DOMINION NUCLEAR CONNECTICUT, INC.
MILLSTONE POWER STATION UNIT 3
RESPONSE TO REQUEST FOR ADDITIONAL INFORMATION REGARDING
STRETCH POWER UPRATE LICENSE AMENDMENT REQUEST
REVISED RESPONSE TO FOLLOW-UPS EEEB-08-0108 THROUGH EEEB-
08-0113 TO QUESTION EEEB-07-0052

Stretch Power Uprate License Amendment Request
Response To Request For Additional Information
Revised Response To Follow-Ups EEEB-08-0108 through EEEB-08-0113 To
Question EEEB-07-0052

NRC Question EEEB-07-0052 Follow-Up (EEEB-08-0108)

Figure 1: Pre- and Post-SPU Environmental Temperature Profiles

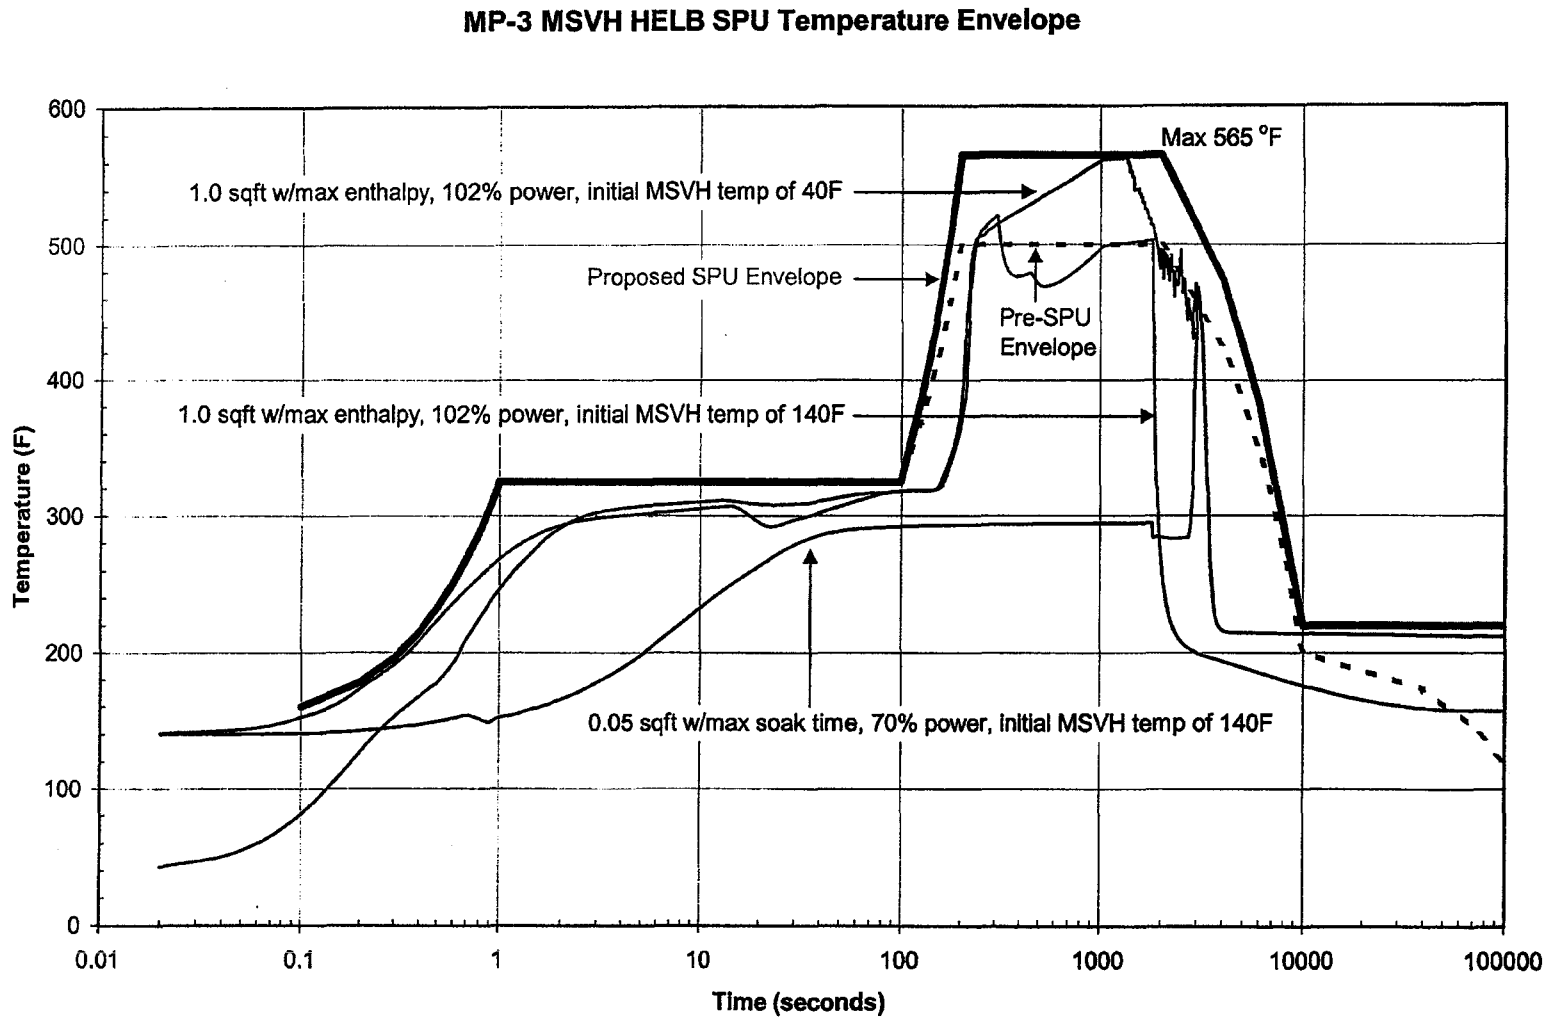
In the March 25, 2008, letter, the licensee states that the analysis for the Main Steam Valve Building (MSVB) following a main steam line break (MSLB) is performed for the duration of the component's mission time. Specify the mission time and function for each of the affected components in the MSVB. Describe the effects of the increased temperature and pressure on the affected components. In addition, explain, in detail, the assumptions and methodology used to evaluate the components. Provide a comparison of the pre-stretch power uprate (SPU) and SPU environmental temperature and pressure profile. Also, provide the detailed environmental qualification (EQ) evaluations and calculations for the ASCO solenoid valves, NAMCo limit switches, Rosemount pressure transmitters, Limatorque motor-operated valves and solenoids associated with Sulzer main steam isolation valves (MSIVs) and ITT actuators.

Provide the worst-case breaks and their impact on the EQ components for the MSVB EQ analysis.

A comparison of the enveloping pre- and post-SPU environmental temperature profiles is provided in Figure 1. The current EQ pressure profile envelopes post-SPU pressure profiles for all cases analyzed. Therefore there is no change to the EQ pressure profile. The enveloping EQ pressure profile is shown in Figure 2.

Figure 3: Pre-SPU Temperature Profiles for ASCO Solenoid Valves

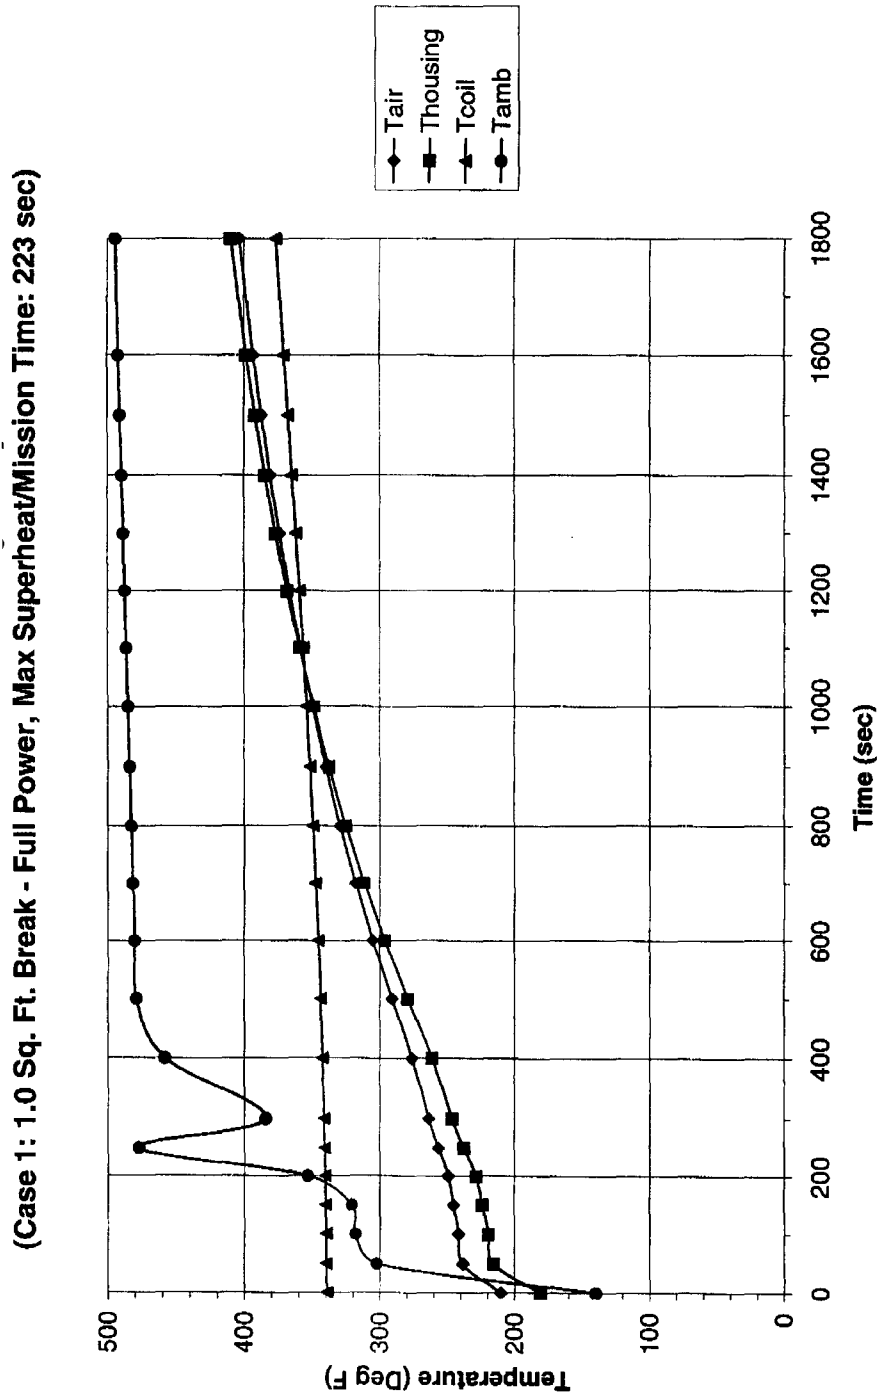
In the March 25, 2008, letter, the licensee states that the outside temperature (i.e. component casing temperature) of the equipment, instead of the internal temperature of the equipment, was conservatively compared with the component qualification temperature. Provide a basis for why the outside temperature is conservative for the affected EQ components.

Pre-SPU ASCO solenoid valve thermal lag analysis used a bounding environment temperature profile (i.e., 1.0 ft² break size, 102% NSSS power level, maximum enthalpy) and a maximum mission time of 1800 seconds. This maximum mission time bounds the MSI times for all break sizes analyzed. The analysis also assumes that the valves are energized to account for coil heat generation. The peak temperatures were determined for the solenoid coil, air gap and coil housing. The maximum post-SPU coil temperature is calculated by conservatively adding the temperature difference between the bounding pre- and post-SPU environment temperature profiles to the calculated peak pre-SPU coil temperature (See note on Figure 3). The peak temperature for pre-SPU environment temperature profile for solenoid valve qualification is 494.2°F (See Figure 3, curve labeled Tamb). The peak temperature identified in the post-SPU environment temperature profile for solenoid qualification is 562.2°F (See Figure 1, curve labeled 1.0 sqft w/max enthalpy, 102%, initial MSVB temperature of 140°F). The pre-SPU solenoid coil temperature at the maximum mission time (1800 seconds) is 377°F (See Figure 3, curve labeled Tcoil). The post-SPU peak coil temperature as identified in the note on Figure 3 is 445°F and remains below the 450°F ASCO solenoid valve qualification temperature.

Note: post-SPU peak coil temperature = pre-SPU peak coil temperature + temperature difference between bounding pre- and post-SPU environmental profiles

$$= 377^{\circ}\text{F} + (562.2^{\circ}\text{F} - 494.2^{\circ}\text{F}) = 377^{\circ}\text{F} + 68^{\circ}\text{F} = 445^{\circ}\text{F}$$

Figure 6: Post-SPU Limitorque Motor Temperature Profiles (with insulation)

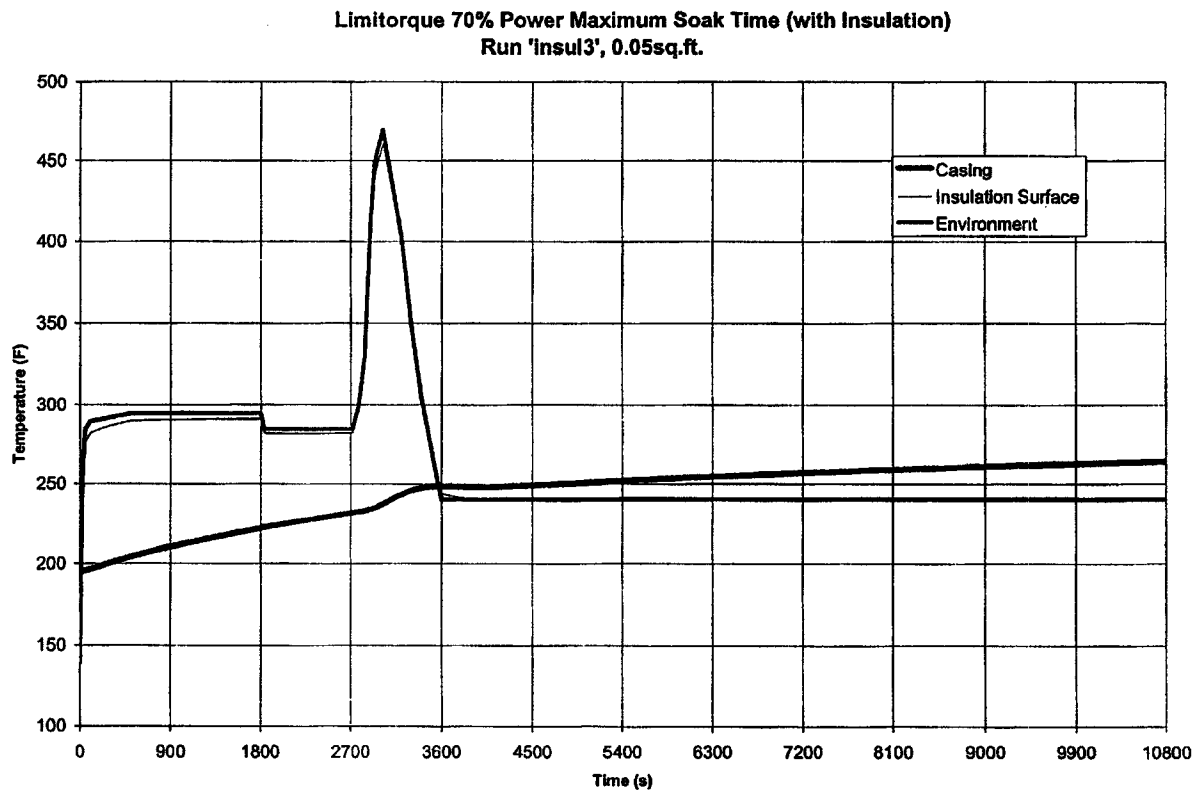
During the March 31, 2008, teleconference, the licensee stated that due to the temperature increase in the MSVB, a design change (enclosing the Limitorque motors with insulation) will be required to maintain the qualification of the motors. Describe the design change in detail and provide a detailed evaluation justifying how this new design, (enclosing the motors with insulation), does not impact the original qualification configuration of the Limitorque motors. In addition, provide a schedule for implementing the aforementioned design change.

The peak MSVB environmental temperatures for all eight cases occur well within 3,600 seconds after break initiation. Therefore, the analysis was run for a period of 10,800 seconds (3 hours). Although the environment temperature drops rapidly after one hour, the analysis assumed a 240.5°F temperature for the remaining portion of the transient. In addition to the external heat flux from the harsh environment to the motor casing, the analysis assumed conductive heat flux from the valve to the motor casing. Therefore comparison of the higher casing temperature to the qualification temperature is conservative. The insulated motor casing temperature at 3 hours is 265°F, which is less than the 315°F motor qualification temperature. Post-SPU temperature profiles of the ambient and the motor casing are provided in Figure 6.

insulate the motors of the 3MSS*MOV18A/B/C/D valve operators prior to exceeding 3411 MWt. The design change will install 1.5 inch thick flexible blanket type insulation covering only the motor. The following activities support the design change process to ensure that 3MSS*MOV18A/B/C/D will perform their intended design function under SPU MSVB HELB environment.

1. An analysis will be performed showing that the motor casing temperature will be less than the motor qualification temperature following a MSLB with the insulation installed. The analysis assumes an insulation thickness of 1.5 inches having a thermal conductivity of approximately 0.326 Btu-in/hr ft² °F. This activity is complete.
